SILVER SPRING GATEWAY
SILVER SPRING, MARYLAND

Hord Coplan Macht LANDSCAPE ARCHITECTURE & PLANNING COMPANIES

ILLUSTRATION TO PROPOSED CHANGE TO SILVER SPRING SQUARE SIGNATURE SET LANDSCAPE DESIGN

1 SILVER SPRING SQUARE APPROVED SIGNATURE SET LANDSCAPE DESIGN
L-6.0 SCALE: NTS

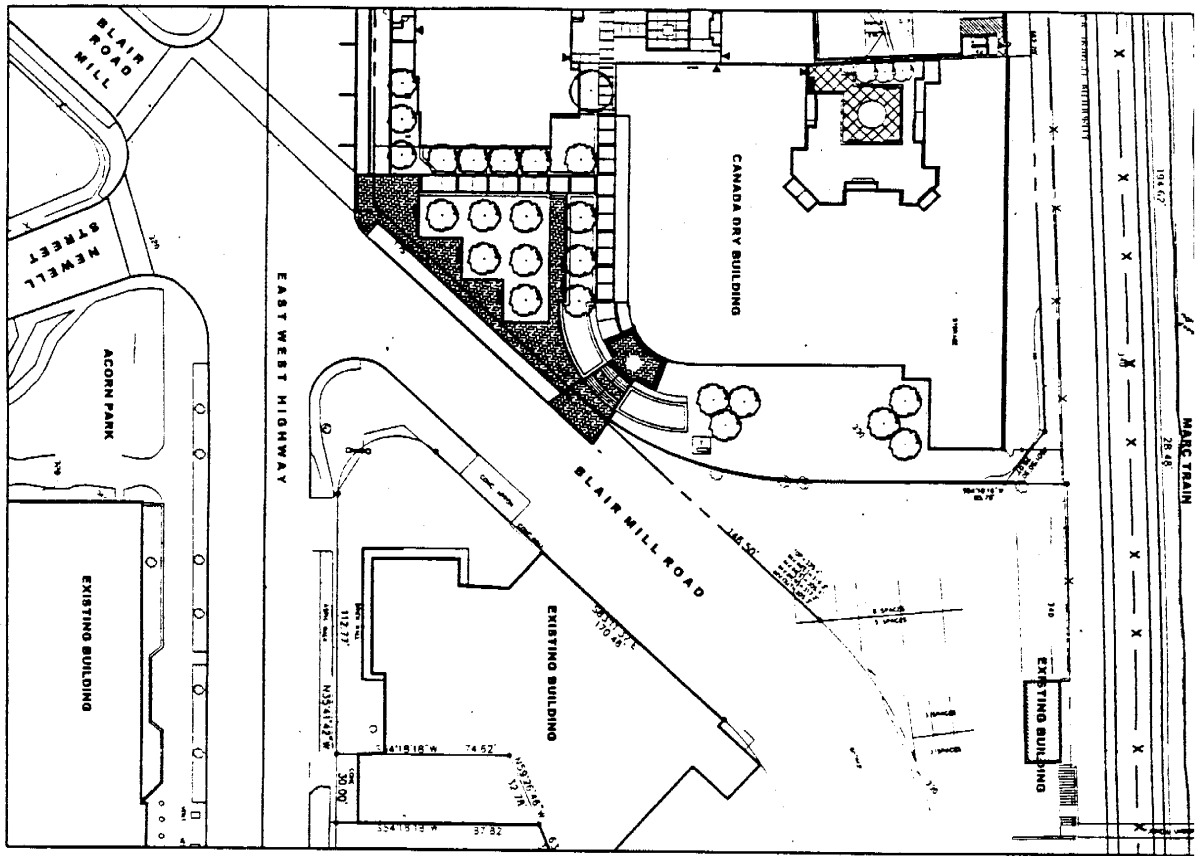
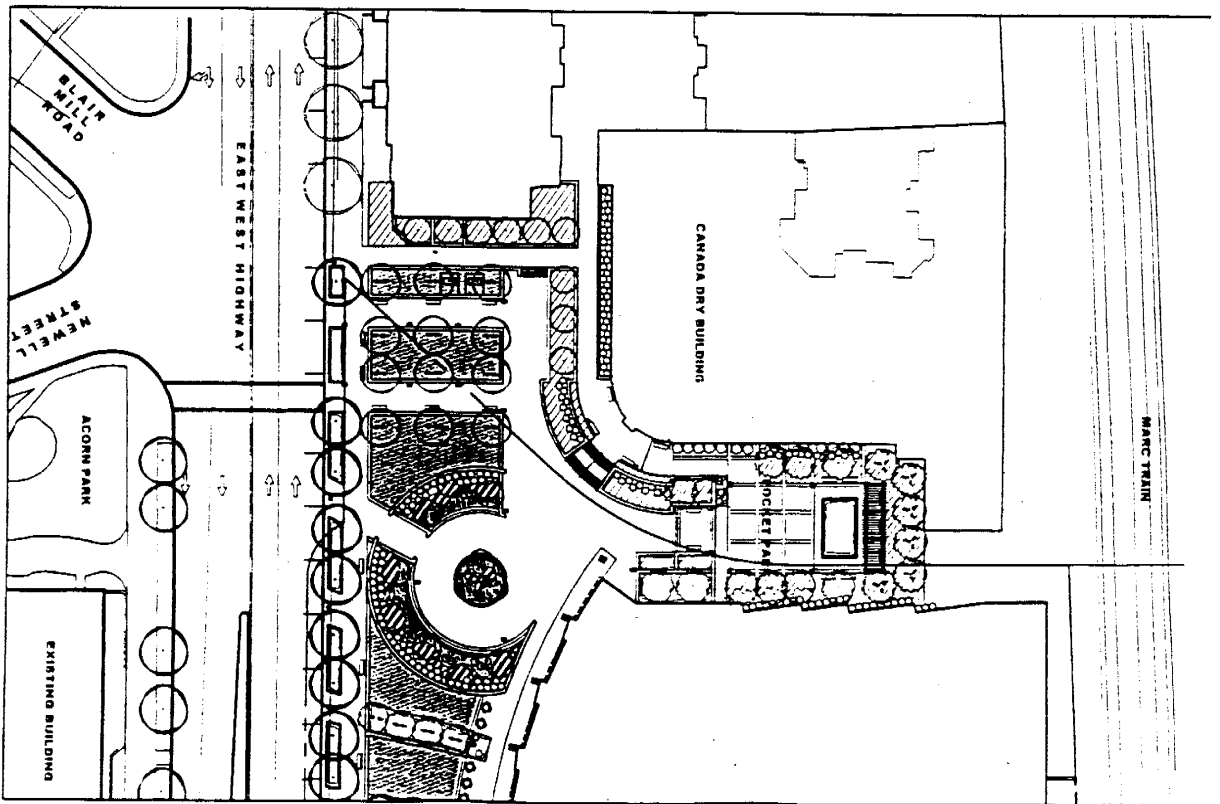
REMOVE EXISTING PLANTER WALL

EXTEND ARTS ALLEY PAVING TO MATCH

This sheet is intended to illustrate proposed changes to the approved Signature Set landscape design for the Silver Spring Square Project as proposed by the Silver Spring Gateway Project Plan, Drawing 1/L-4.0. Illustrates the approved Signature Set landscape design for the Silver Spring Square Project to be constructed if Blair Mill Road is left in place.

This sheet is intended to illustrate proposed changes to the approved Signature Set landscape design for the Silver Spring Gateway Project Plan. In drawing two, Blair Mill Road is abandoned and the land is incorporated into both the Silver Spring Square and Silver Spring Gateway projects. The Silver Spring Gateway Project Plan proposes a large urban public plaza space and a smaller pocket park, both of which straddle the property line dividing the two projects.
